SUBJECT: AMENDMENT NO. 126 TO FACILITY OPERATING LICENSE NO. DPR-50

THREE MILE ISLAND NUCLEAR STATION, UNIT NO. 1

AMENDMENT TO FACILITY OPERATING LICENSE

Amendment No. 126
License No. DPR-50

ROD POSITION LIMITS FOR
3 PUMP OPERATION AFTER
250±10 EFPD

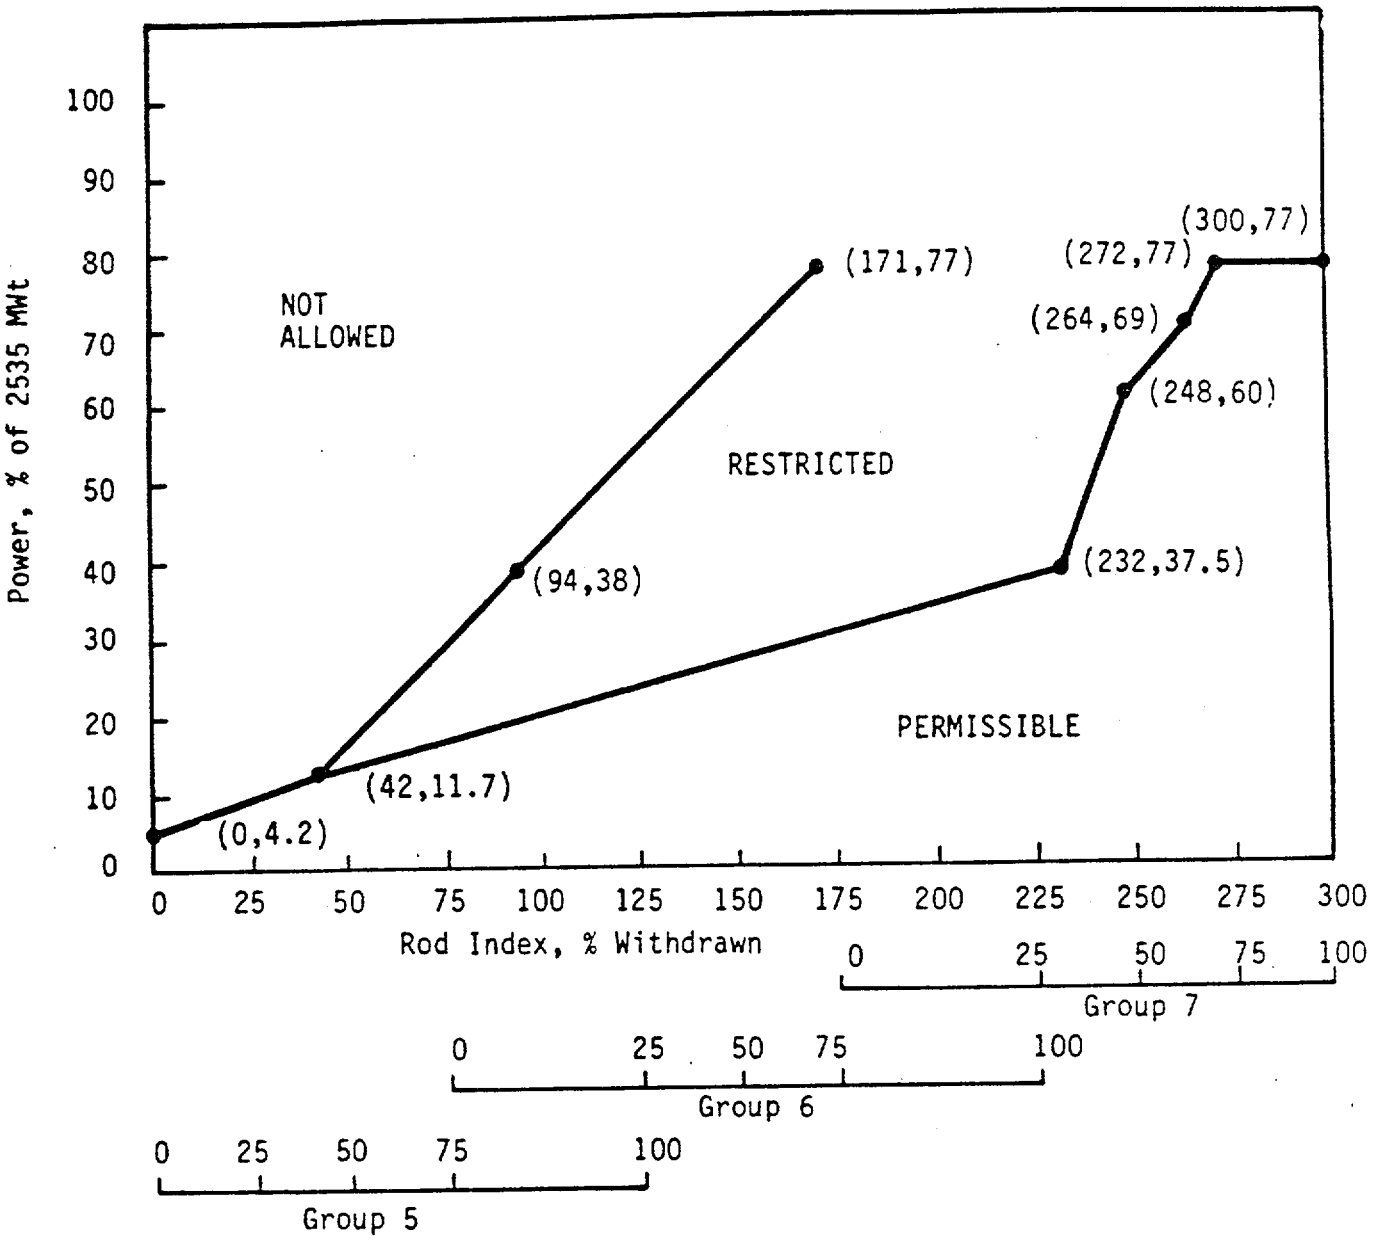
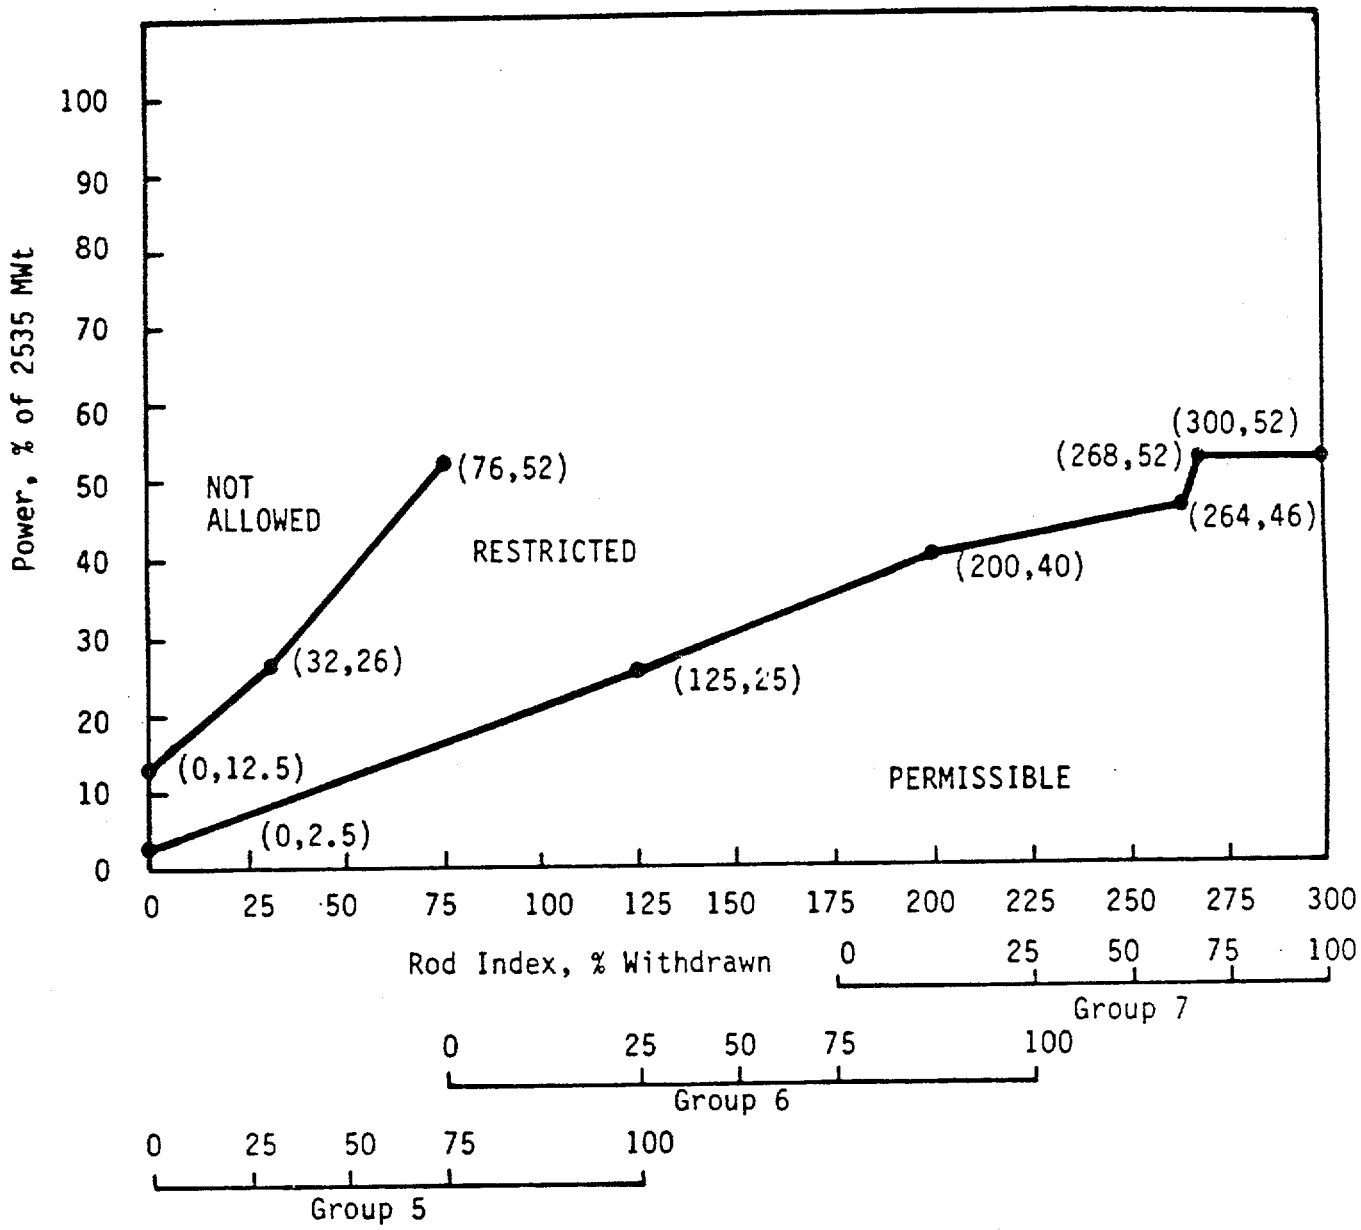
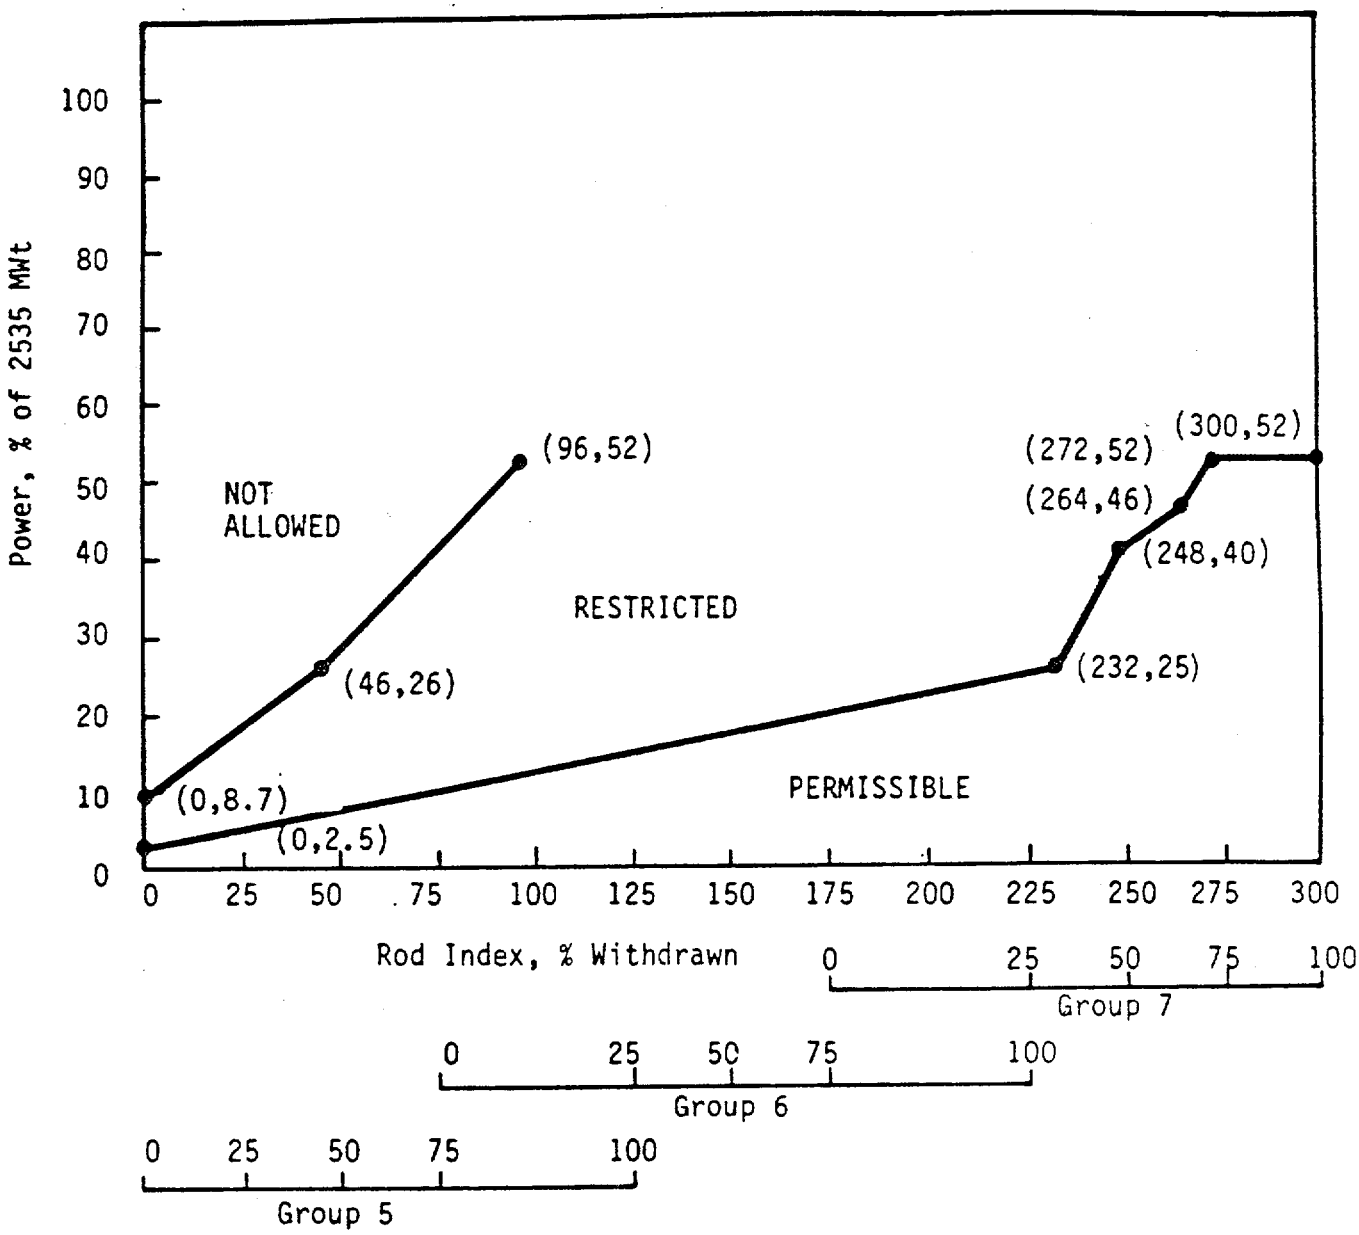
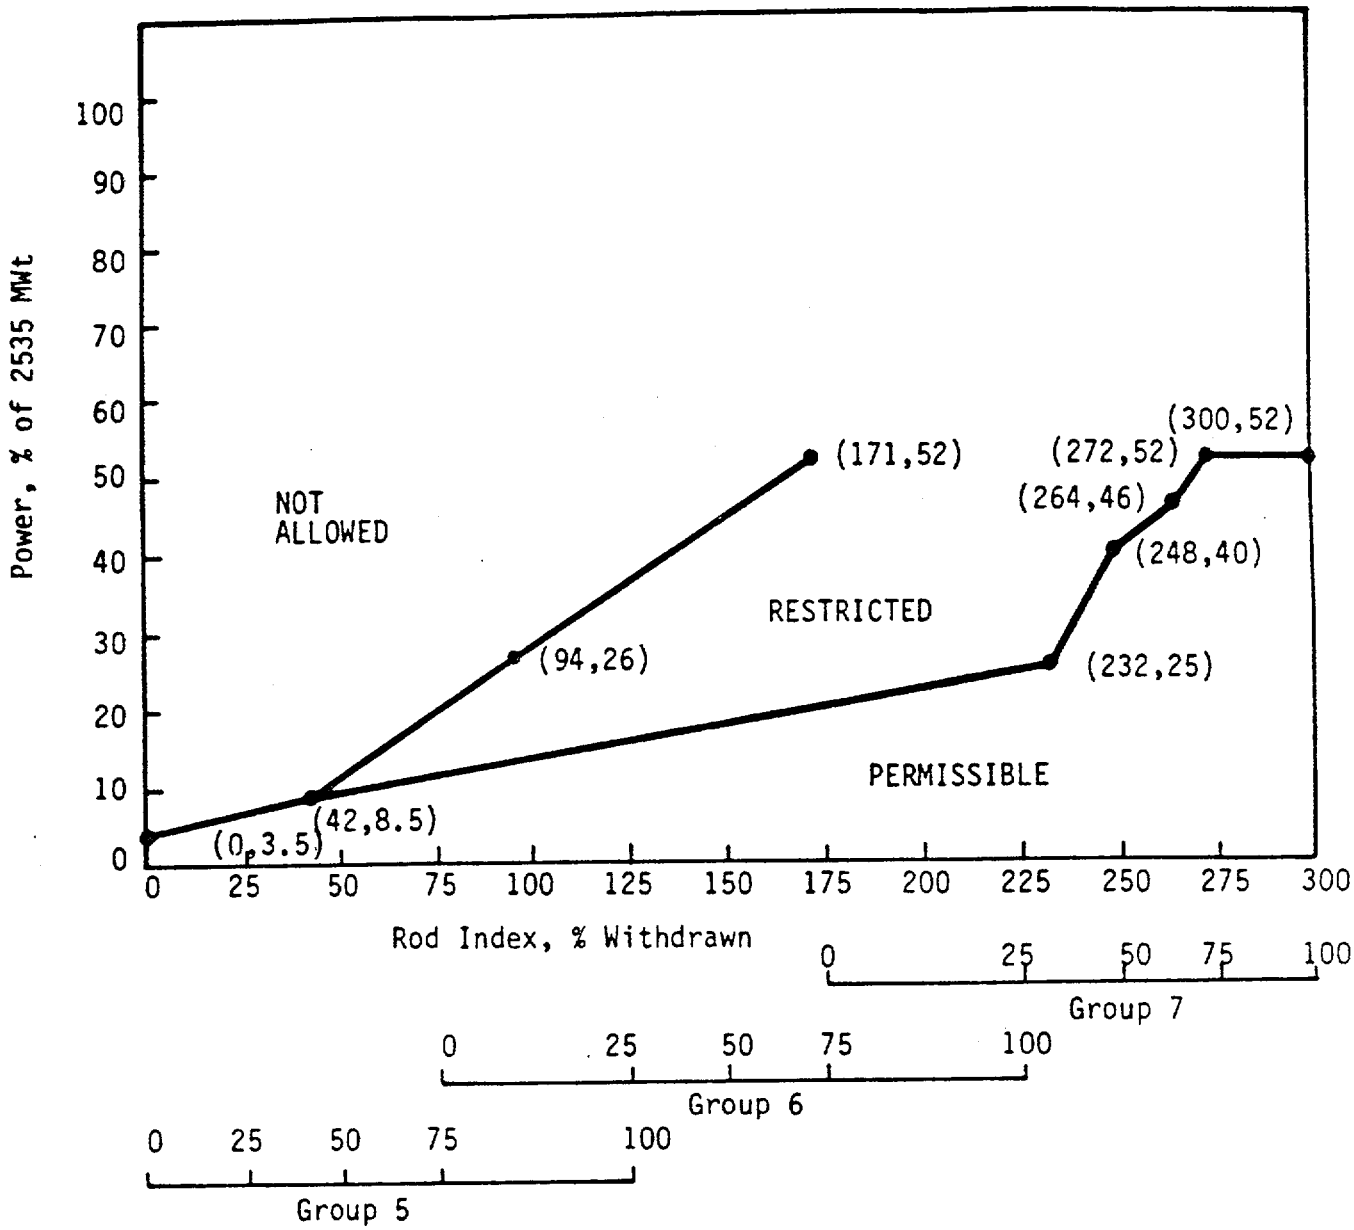
New control rod insertion limits (Figure 3.5-2A through Figure 3.5-2I) are provided for 4, 3 and 2 pump operation, as well as a function of burnup interval. These Figures are acceptable since they are based on the Cycle 6 safety analysis discussed previously.

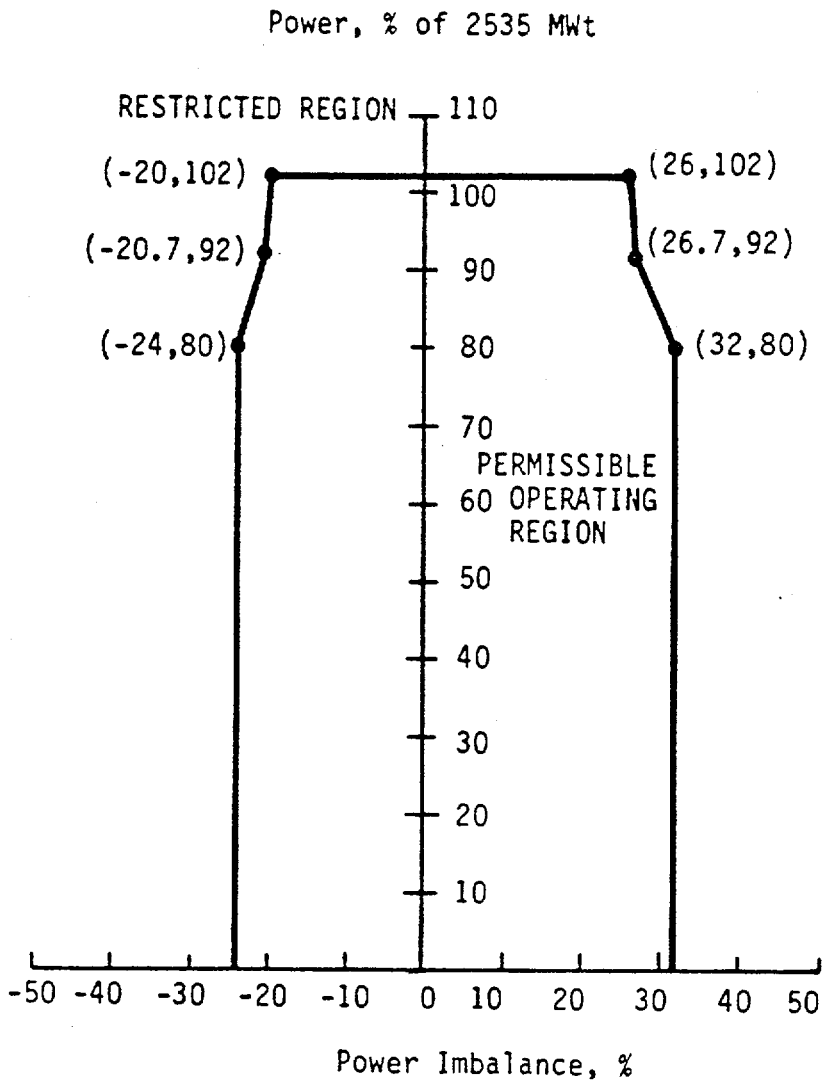
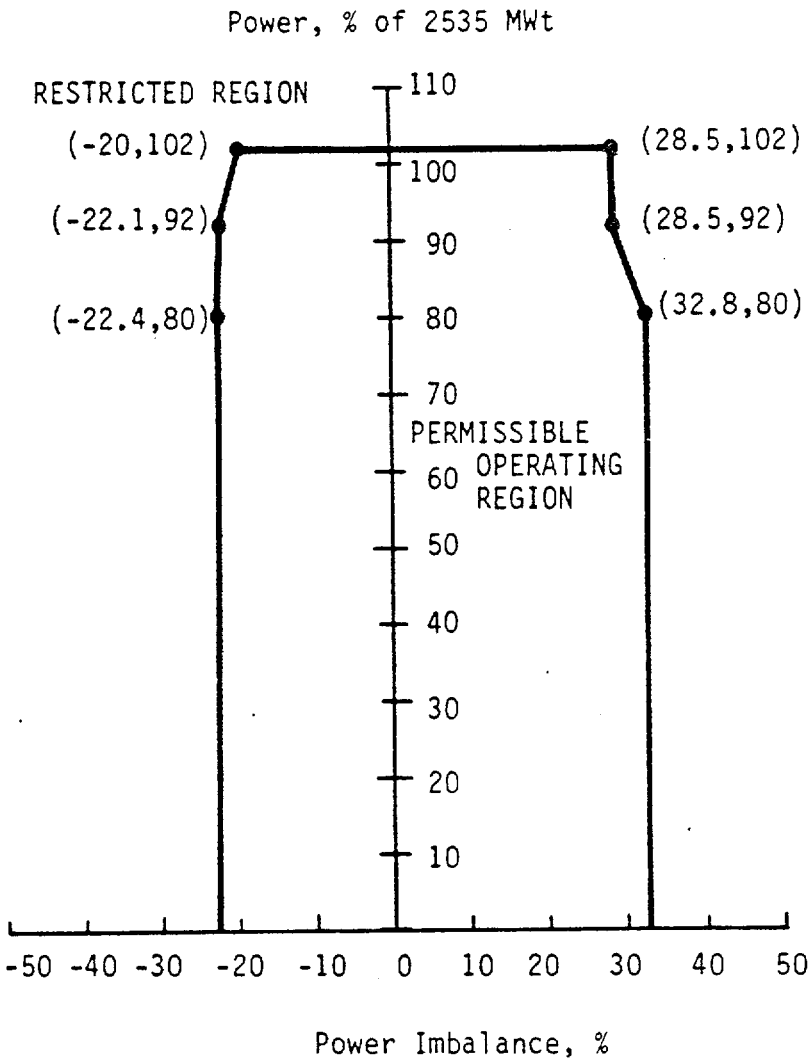
New reactor power imbalance limits (Figure 3.5-2J and Figure 3.5-2K) are provided for two different burnup intervals. These Figures are acceptable since they are based on the Cycle 6 safety analysis discussed previously.

Figure 3.5-2L

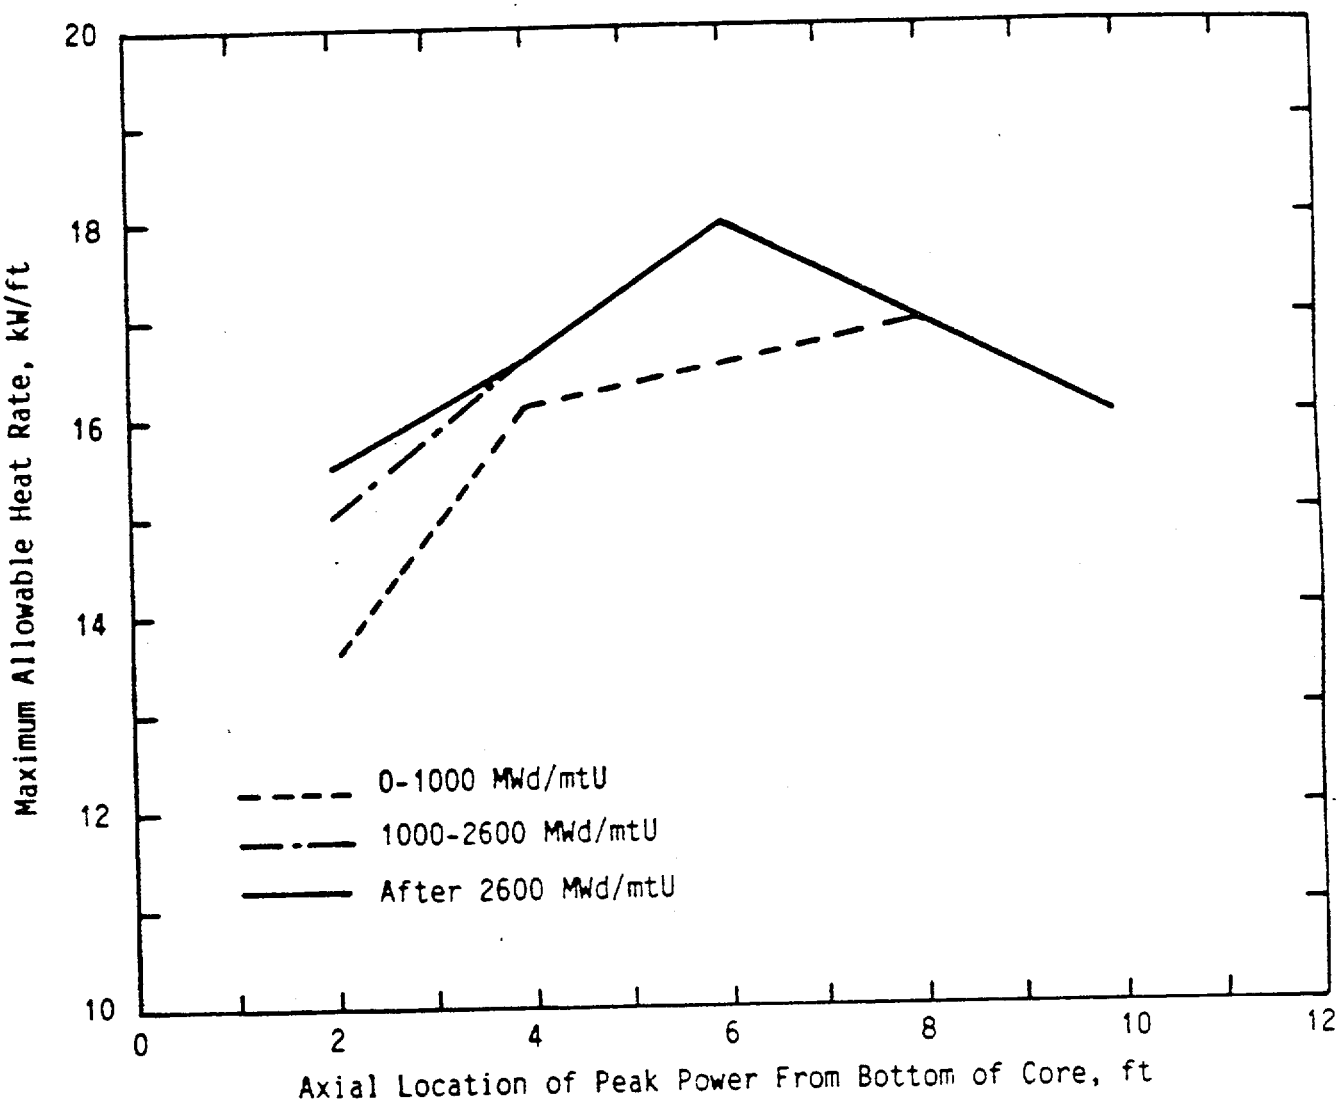
Technical Specification 3.5.2.7 reflects a new figure number. This change is acceptable since it is administrative.

20. Figure 3.5-2L, LOCA Limited Maximum Allowable Linear Heat Generation Rate
